ALERT SERVICE BULLETIN

CHECKING OF THE OIL PUMP FIXING BOLTS FOR CORRECT TORQUE FOR ROTAX® ENGINE TYPE 912 AND 914 (SERIES)

ASB-912-060

ASB-914-043

Fig. 1
Oil pump 912/914 Series

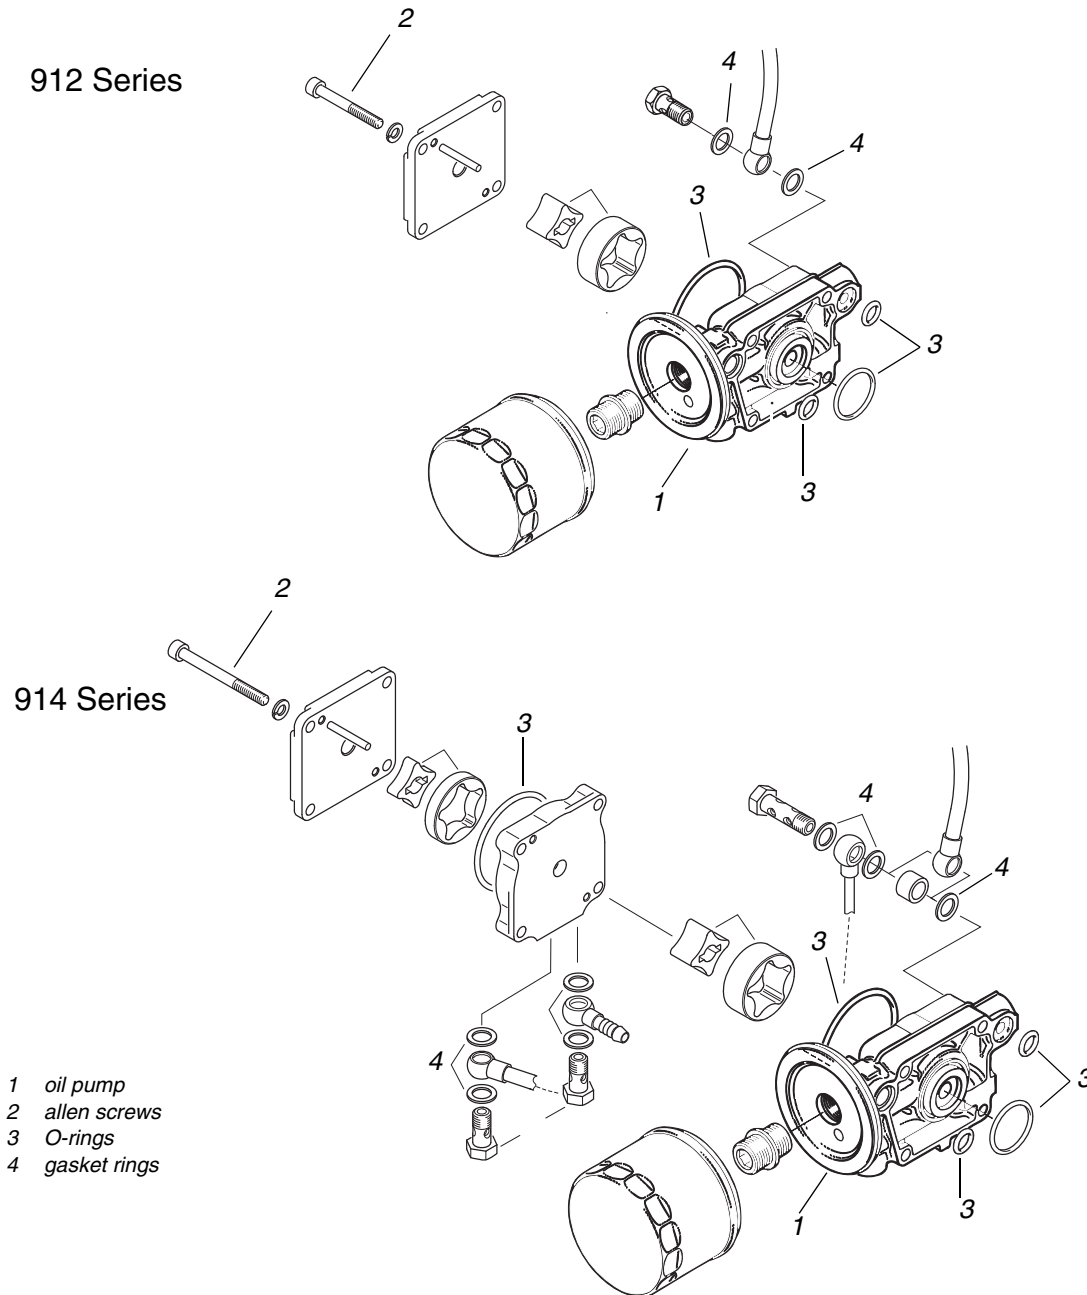
1. Perform inspection for oil leaks in the area of the oil pump. See fig. 1.
2. If you notice oil leaks then all following tasks have to be performed from section 3.1.1 to 3.3 inclusive.
3. If you notice no oil leaks then only the section 3.1.1 need to be performed.

1. Check and/or tighten the 4 oil pump (1) allen screws (2) with lock washer to 10 Nm (90 in.lb.).

1. Remove the oil pump in accordance with the relevant Maintenance Manual (Heavy).
2. Inspect the surfaces for wear, cracks or damages.
3. Replace all O-rings (3) and gasket rings (4). Spare and replacement parts should be ordered using the current Illustrated Parts Catalog.
4. Install the oil pump in accordance with the relevant Maintenance Manual (Heavy).

Fig. 2
valve train

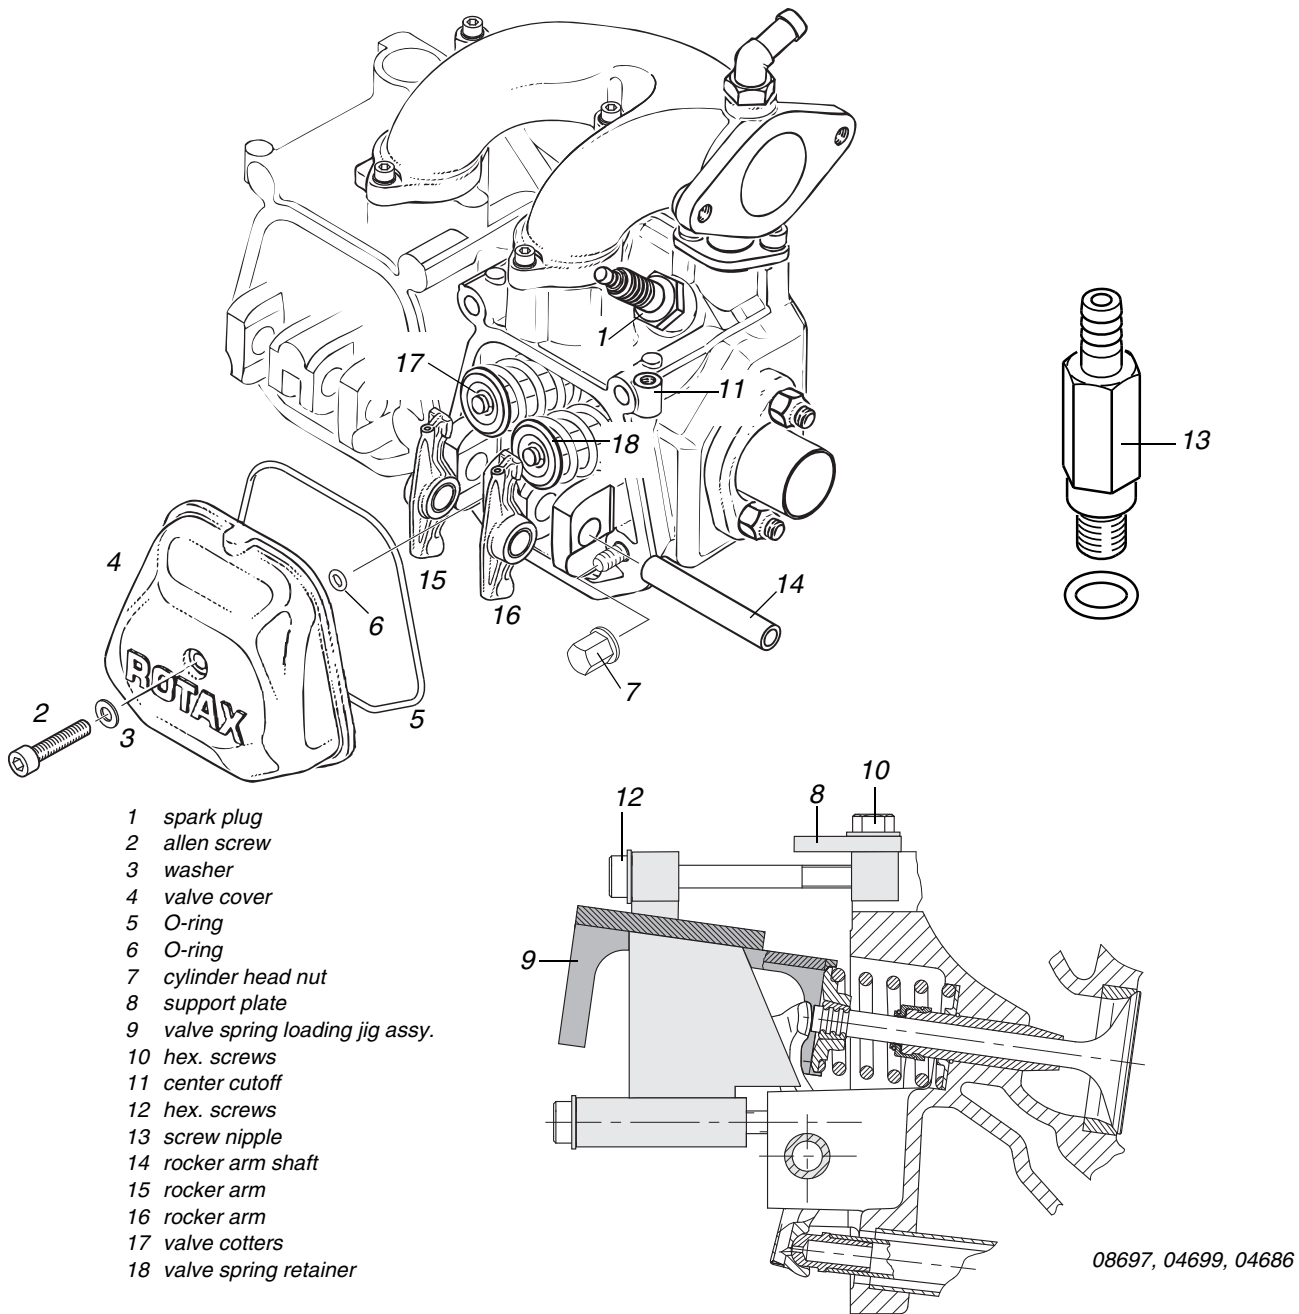
The following steps are necessary to rule out a pre-damage of the valve train:

1. Remove the spark plug connector and the 4 top spark plugs (1).

2. Remove Allen screw (2) M6x30 with washer (3) from valve cover (4).
3. Remove large and small O-ring (5) and (6).
4. Tap valve spring retainers slightly with a soft mallet to loosen valve spring retainers from the valve cotters.
5. Turn crankshaft so that the respective piston is exactly on ignition top dead centre (compression stroke).
6. Remove the external cap nut (7) (exhaust side of cylinder).

- 7. Attach the support plate (8) for the valve spring loading jig (9) with 2 hex. screws (10) M6x16 at the attachment points (11) on the cylinders.
- 8. Attach the valve spring loading jig on cylinder head and support plate with 2 Allen screws (12) M6x70.

1. Insert the washers.
2. Insert the inlet- and outlet valve springs.
3. Re-fit the valve spring loading jig assy (9) analogous to procedure for removal of the valve spring retainers.
4. Depress the 2 valve springs evenly by screwing in the 2 Allen screws (12) until the valve cotters can be inserted.

10. Place inlet rocker arm (15) and outlet rocker arm (16) into position, apply MOLYKOTE G-N on both ends of rocker arm shaft (14) and insert it into its bore in cylinder head.

11. Remove the valve spring loading jig (9) and the support plate (8).
12. Re-install cylinder head nut as per current Maintenance Manual.
13. Verify proper fit of the valve cotters and secure fit in valve spring retainer by tapping with a soft mallet.
14. Lubricate all moving parts in the rocker arm space.
15. Clean the sealing surface of cylinder head and valve cover.
16. Insert new O-ring (5) 105x2,5 and O-ring (6) 6,4x1,8 into the valve cover (4).
17. Fit valve cover.

18. Tighten the new Allen screw (2) M6x30 with washer (3) to 10 Nm (90 in.lb.).
